RESPONSE LETTER NO. 2 TO REQUEST FOR INFORMATION

Project Title: Stormwater Pump Stations and Control Structures Improvements

Project No.: 20230219

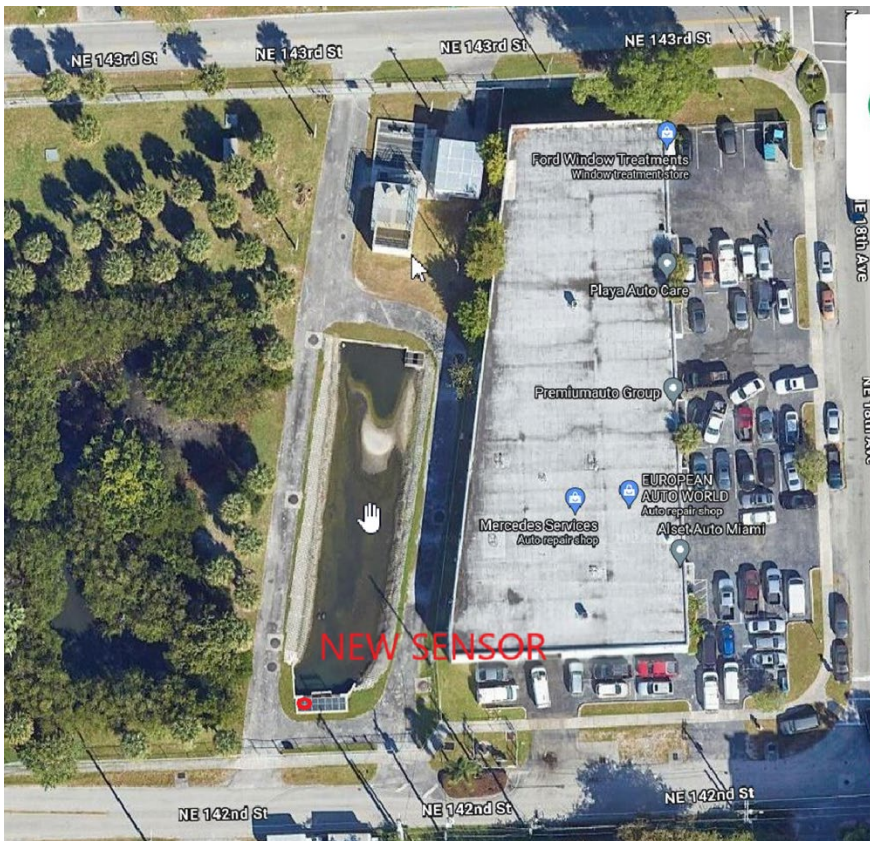
QUESTION: 1) Arch Creek 1 does not appear to have a canal level instrumentation structure (underground and place to install new equipment). Please advise if it exists or if it needs to be included as a build structure.

RESPONSE: 1) Arch Creek does not have an existing canal sensor. The contractor will need to install new cable and conduit to connect proposed canal sensors to an RTU panel. Revised location of proposed canal sensor as follows:

Arch Creek 1

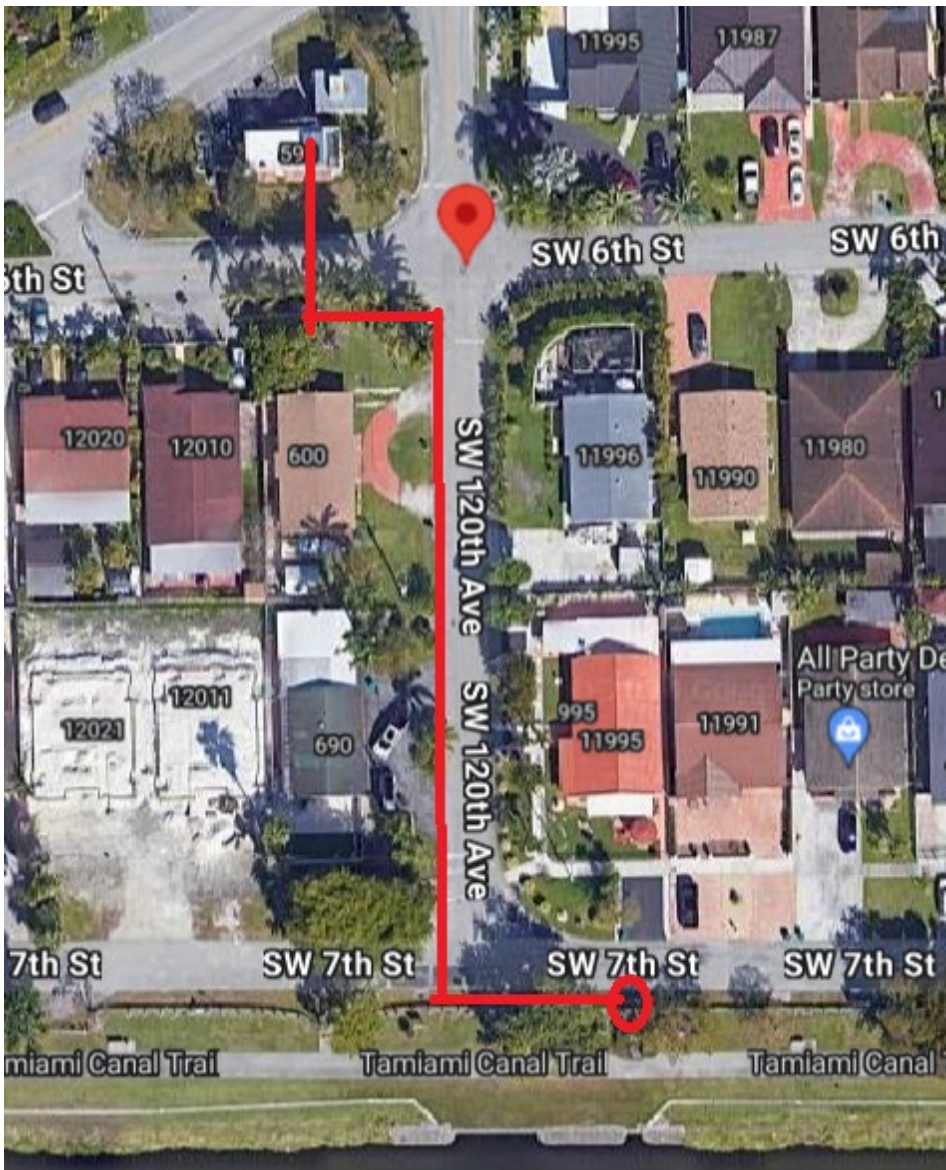
1. Arch Creek 1 does not appear to have a canal level instrumentation structure (underground and place to install new equipment). Please advise if it exists or if it needs to be included as a build structure.
2. Please advise if Belen 1 and 2 have a canal level instrumentation structure, underground and place to install new equipment or if it needs to be included as a build structure.

RESPONSE: 2) Belen 1 and 2 have an existing canal sensor and conduit. However, the contractor must install the necessary cable to connect them to their respective RTU's.
